PROJECT TITLE
Owens Park, Fallowfield;
Campus Redevelopment

DRAWING TITLE
East and South Facing Elevations - Building 107

Exterior Material Amendments Schedule

This schedule issue sets out amendments to items 9, 10 and 11 and acts to supersede the relevant parts of the BDP document (SCH)_A034_Exterior Material Schedule.

SOUTH ELEVATION
1 : 100

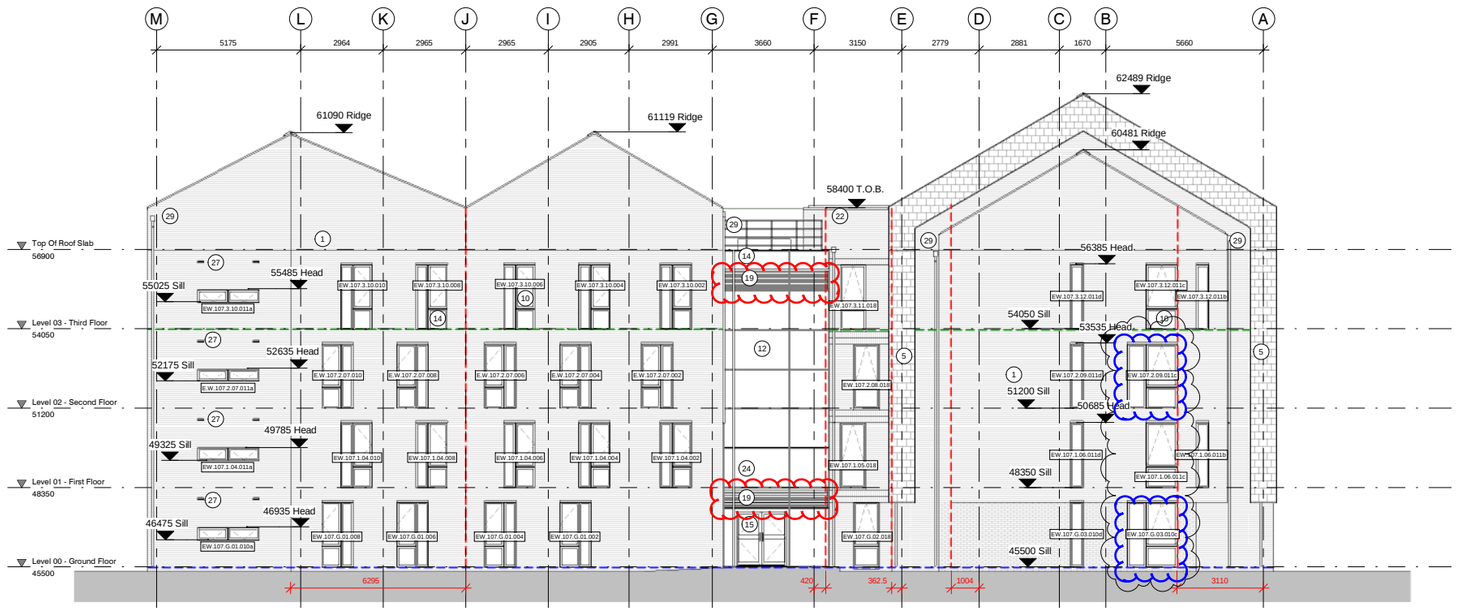
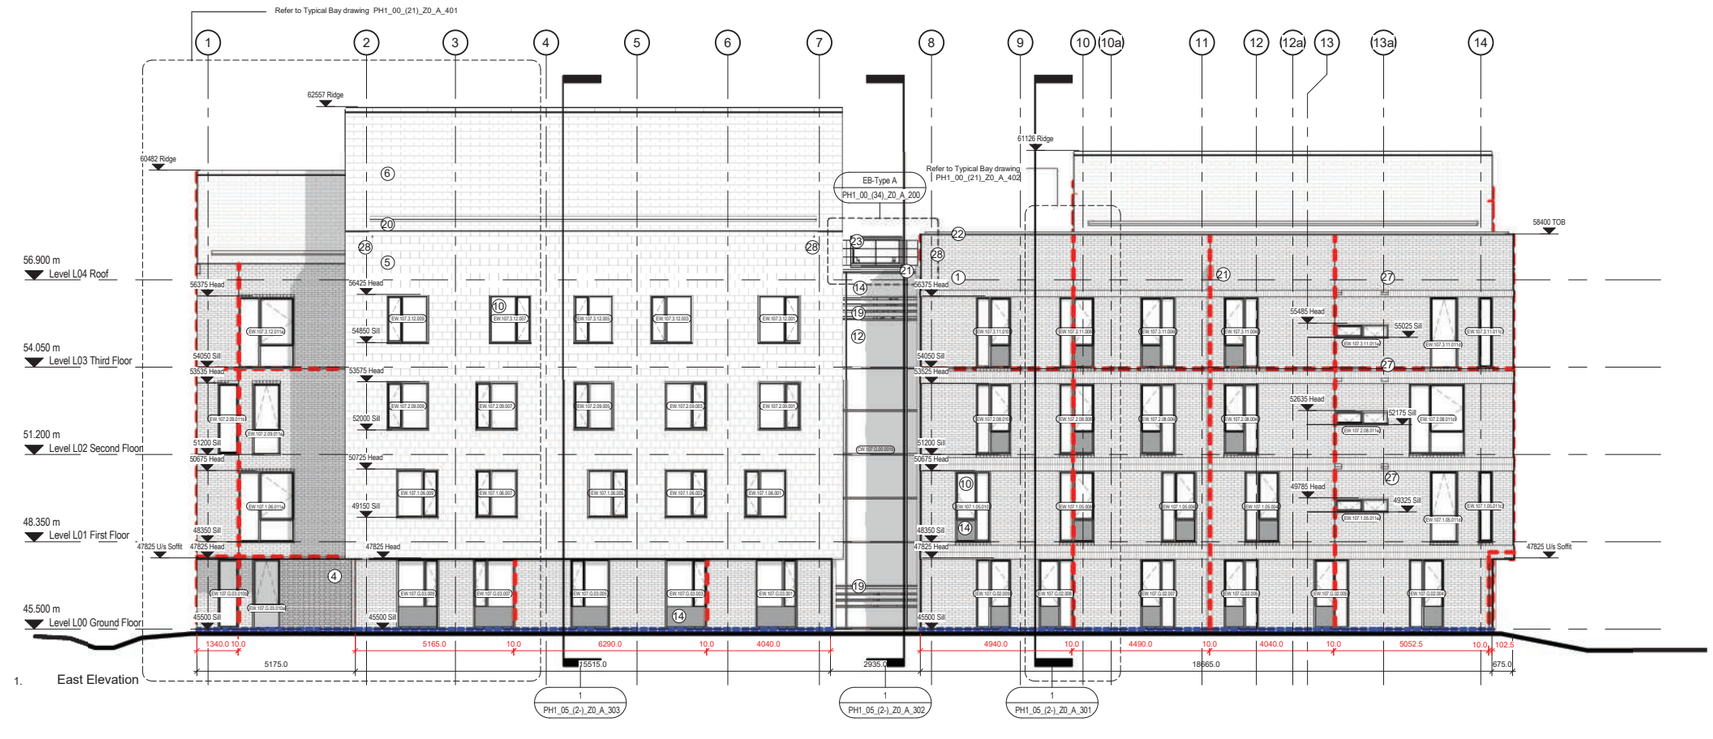
WINDOWS IN BLUE AMENDED TO BE TOP HUNG.

GLASS LOUVRES AMENDED TO BE PPC METAL

WEST ELEVATION
1 : 100

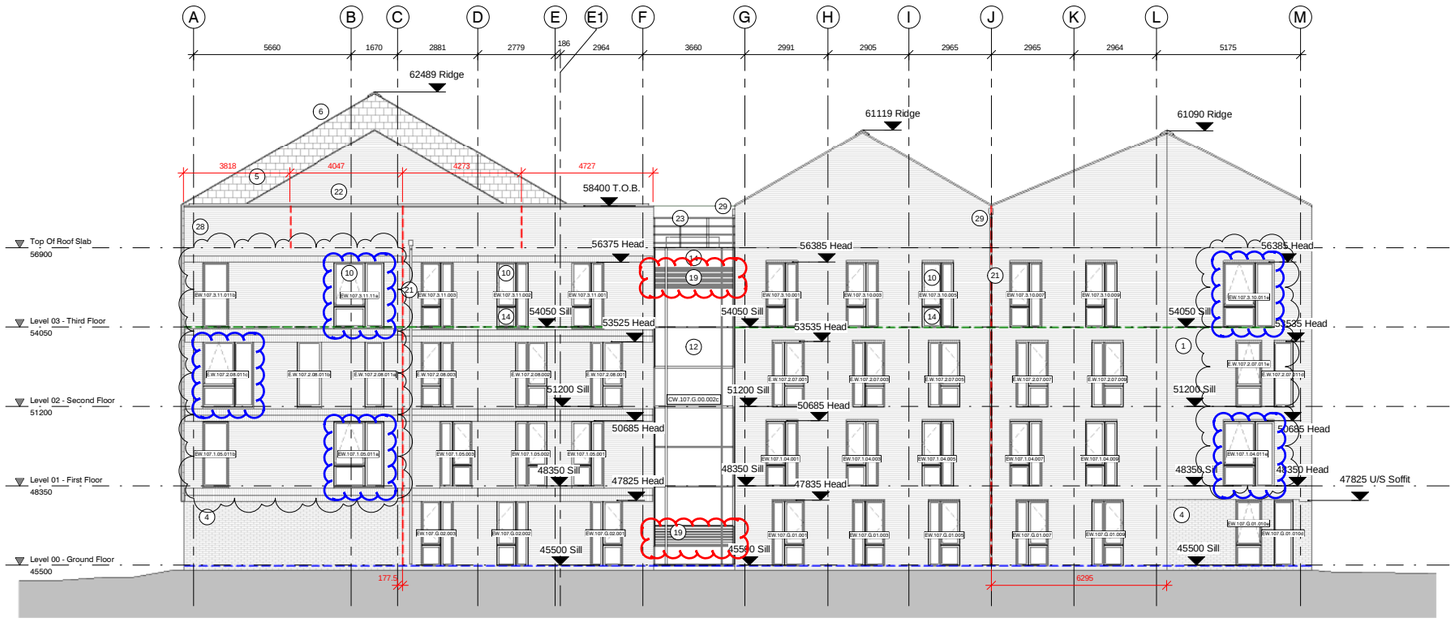
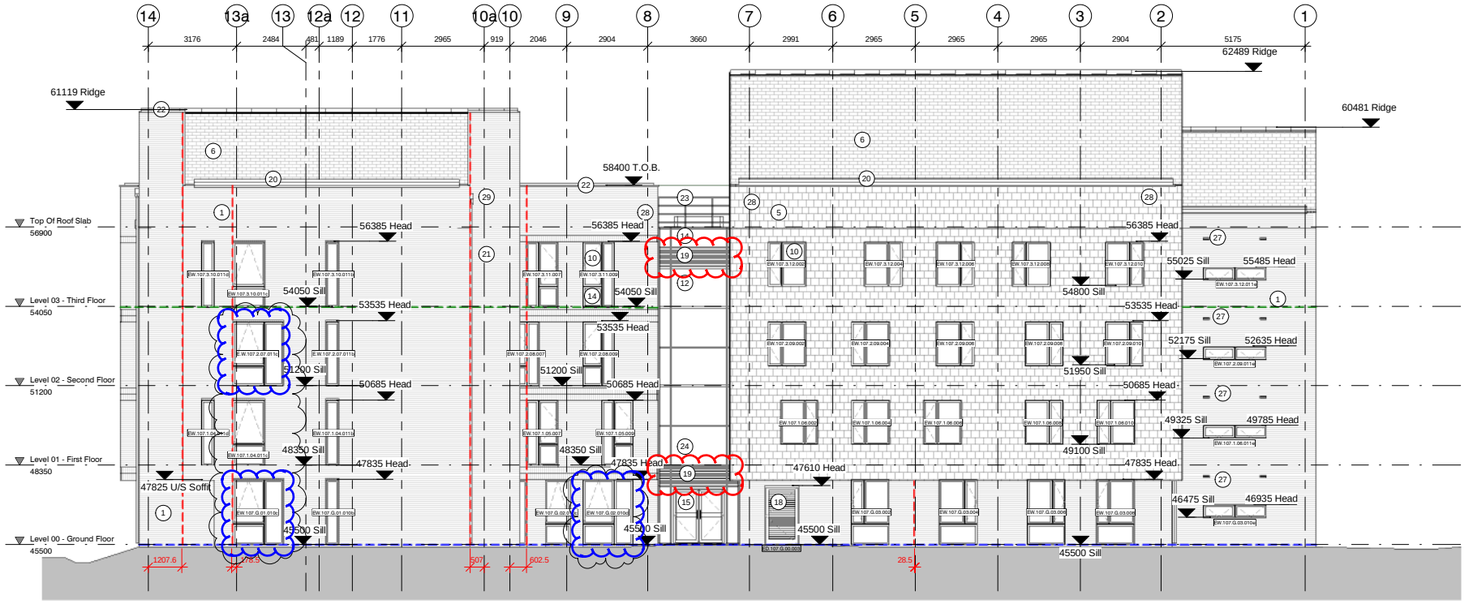
WINDOWS IN BLUE AMENDED TO BE TOP HUNG.

GLASS LOUVRES AMENDED TO BE PPC METAL

DRAWING TITLE
Internal Elevations - Building 107

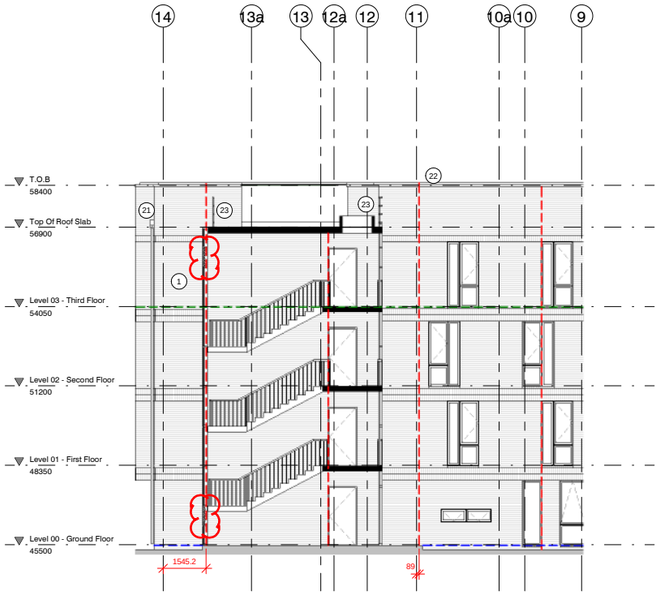
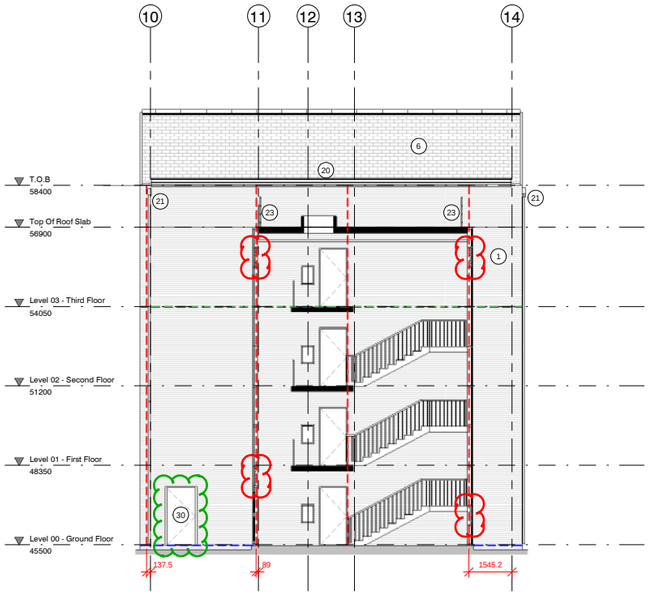
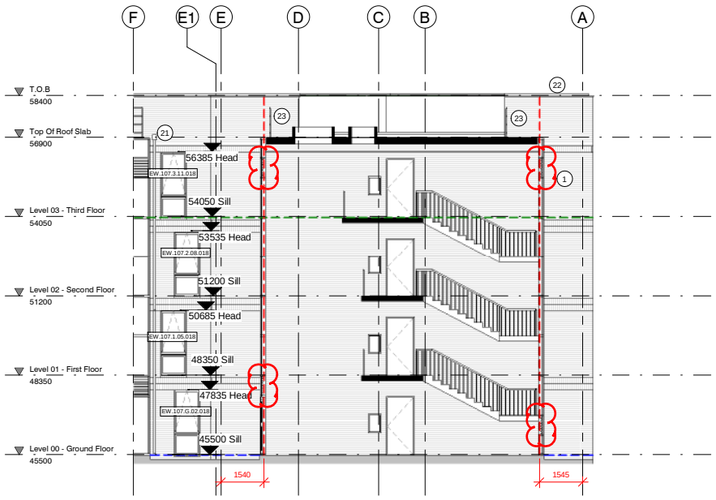
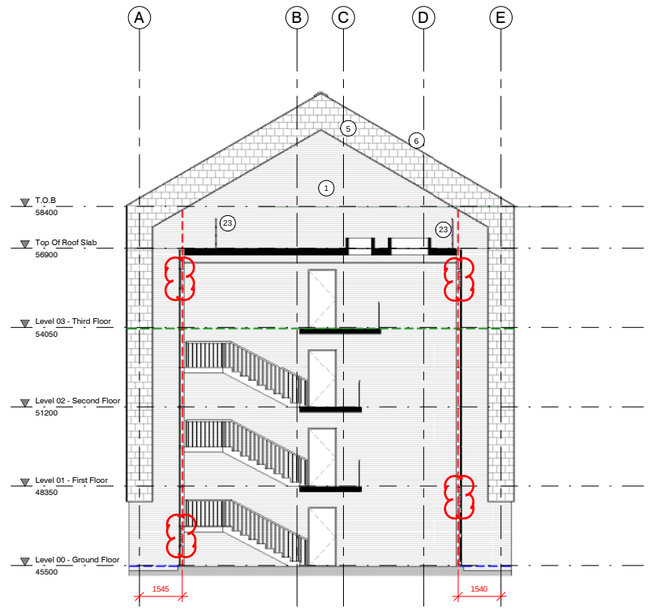
GLASS LOUVRES AMENDED TO BE PPC METAL

DOOR IN GREEN AMENDED TO BE SOLID METAL LOUVRES REMOVED

DRAWING TITLE
South and East Elevations - Building 108

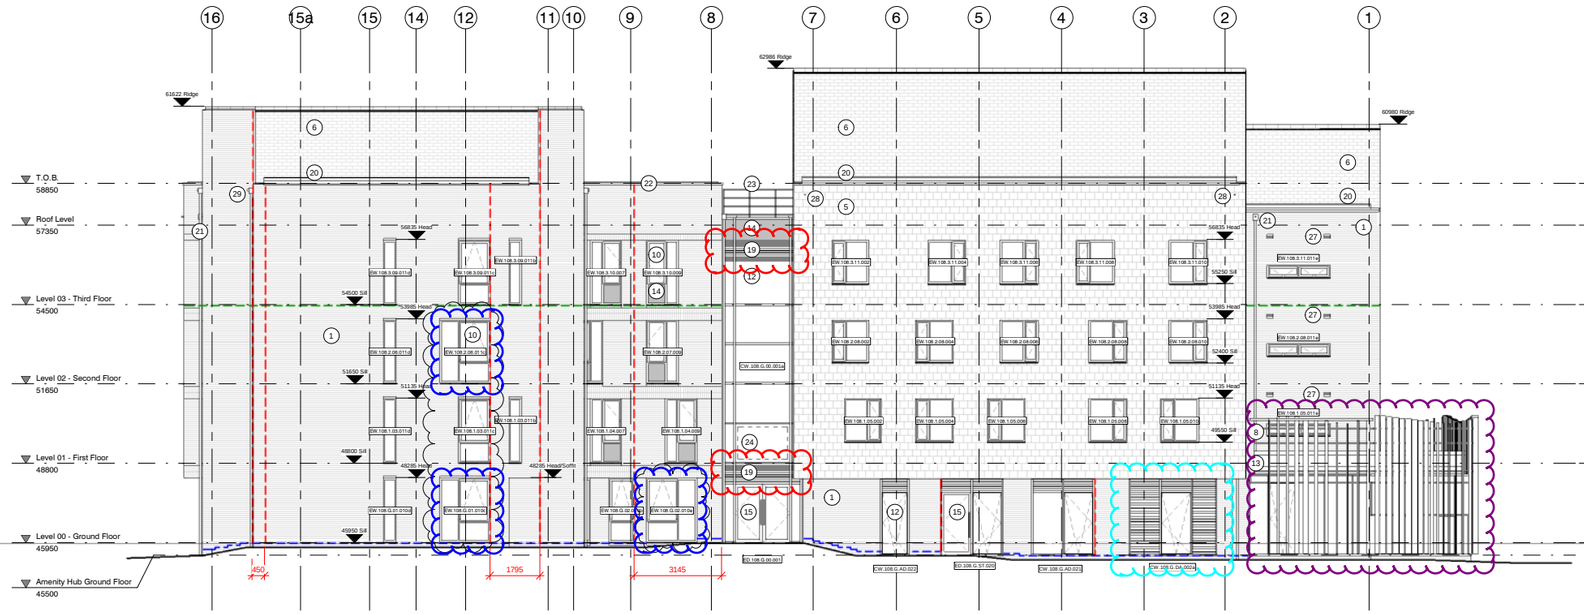
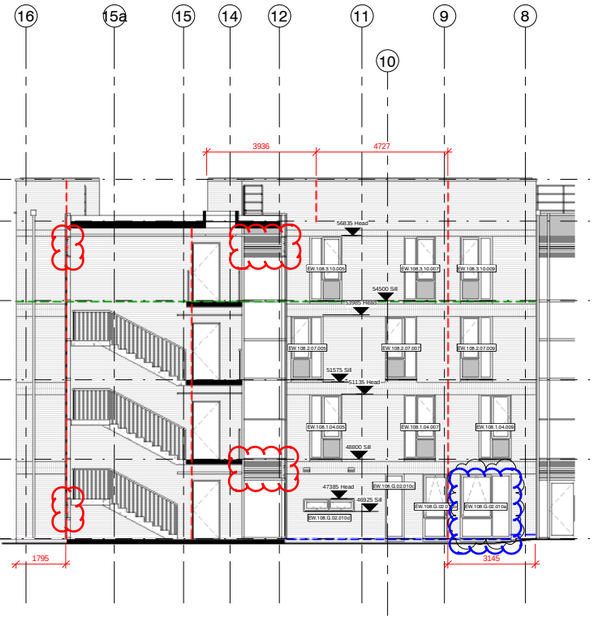
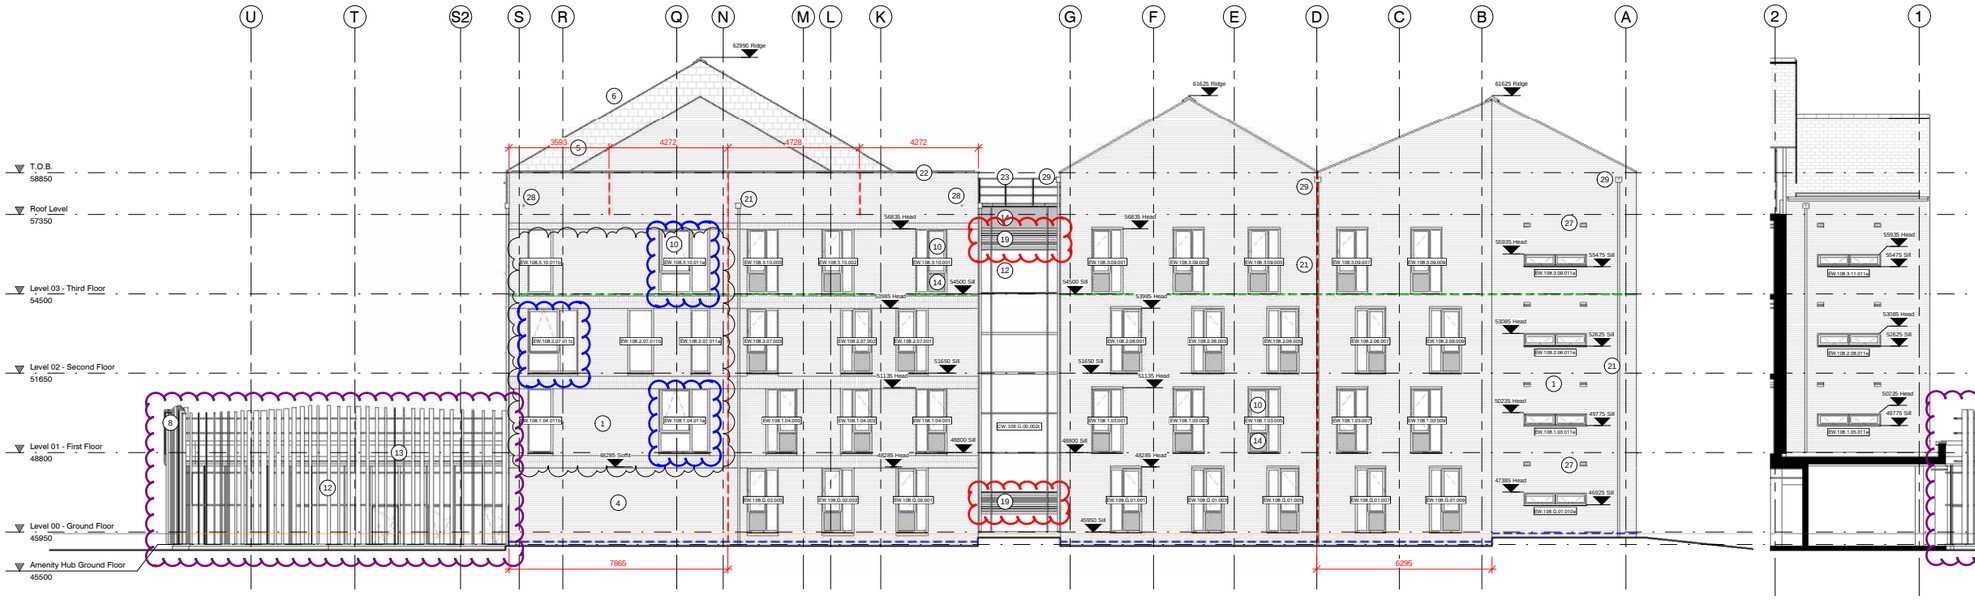
CURTAIN WALLING TO LAUNDRY AMENDED

WINDOWS IN BLUE AMENDED TO BE TOP HUNG.

GLASS LOUVRES AMENDED TO BE PPC METAL

AMENDMENTS MADE TO FIN HEIGHTS AND MATERIAL (NOW PPC METAL), AMENITY HUB ENTRANCE SURROUND CHANGED TO BRICK

DRAWING TITLE
North and West Elevations - Building 108

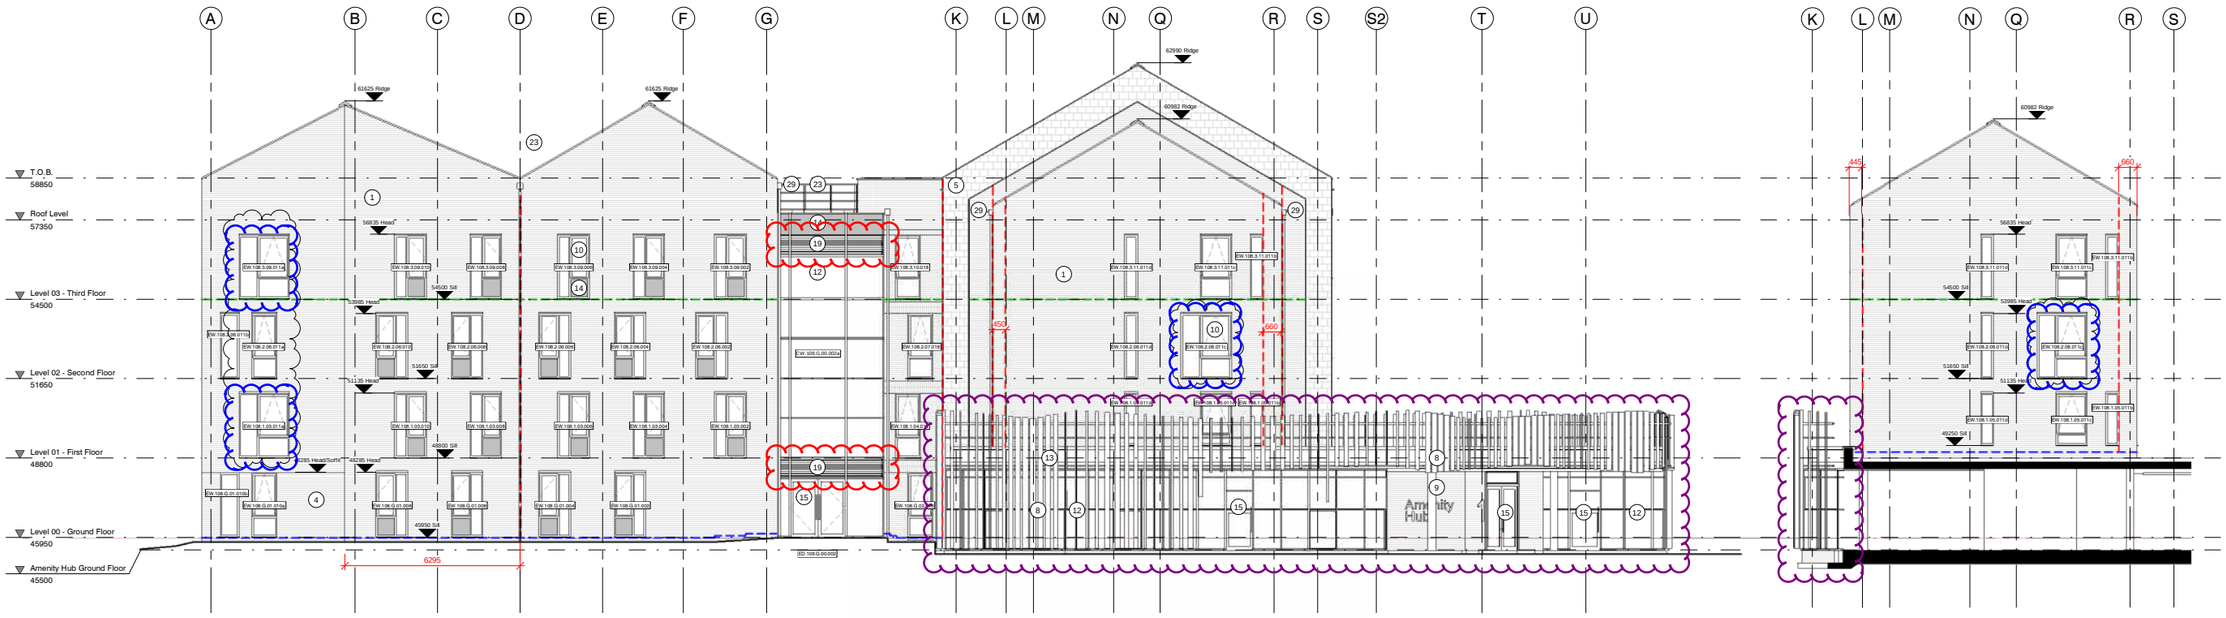
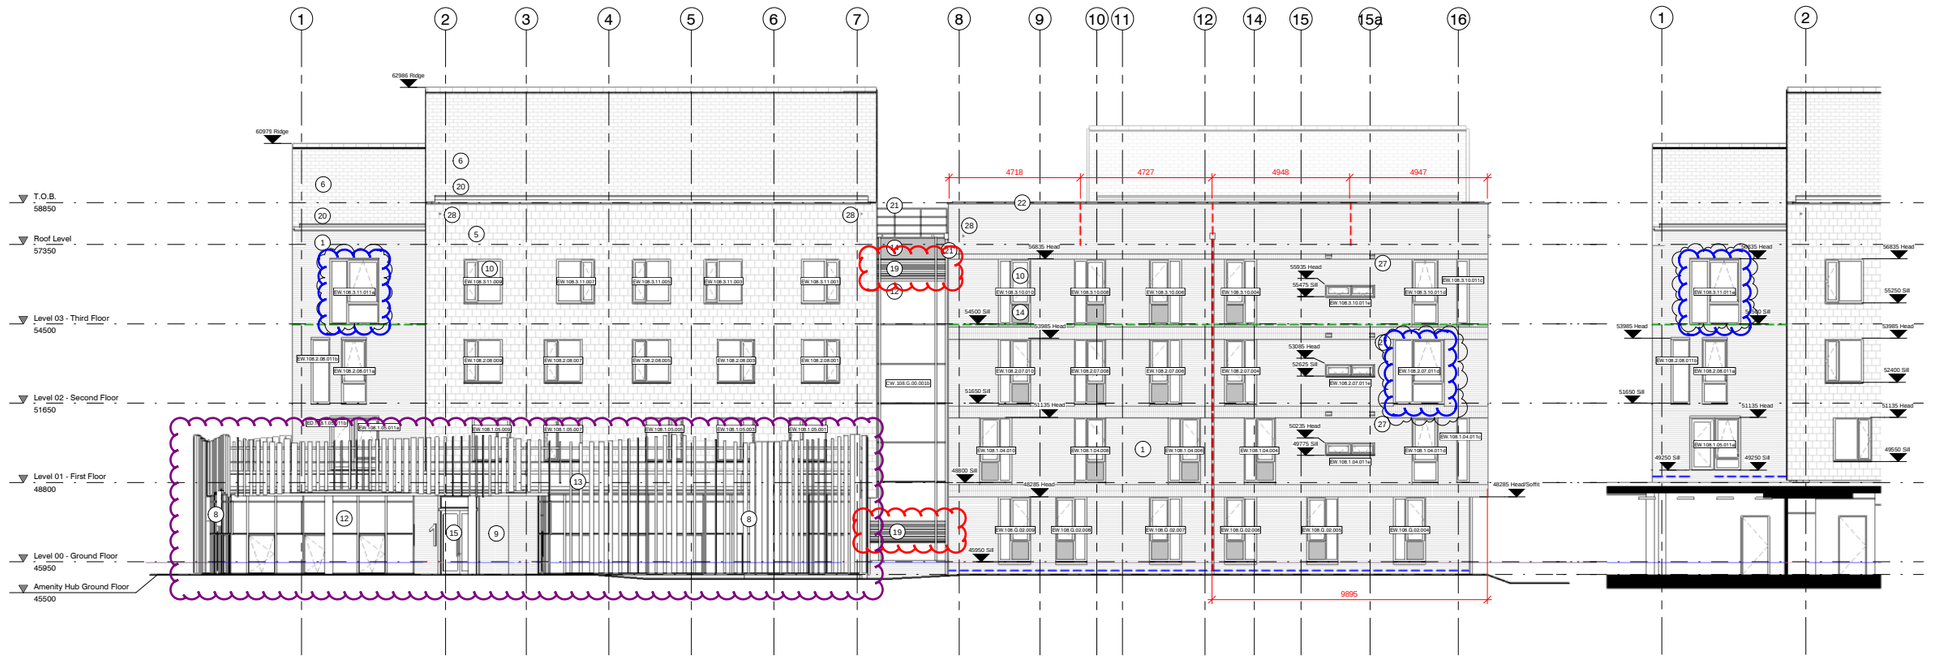
WINDOWS IN BLUE AMENDED TO BE TOP HUNG.

GLASS LOUVRES AMENDED TO BE PPC METAL

AMENDMENTS MADE TO FIN HEIGHTS AND MATERIAL (NOW PPC METAL), AMENITY HUB ENTRANCE SURROUND CHANGED TO BRICK
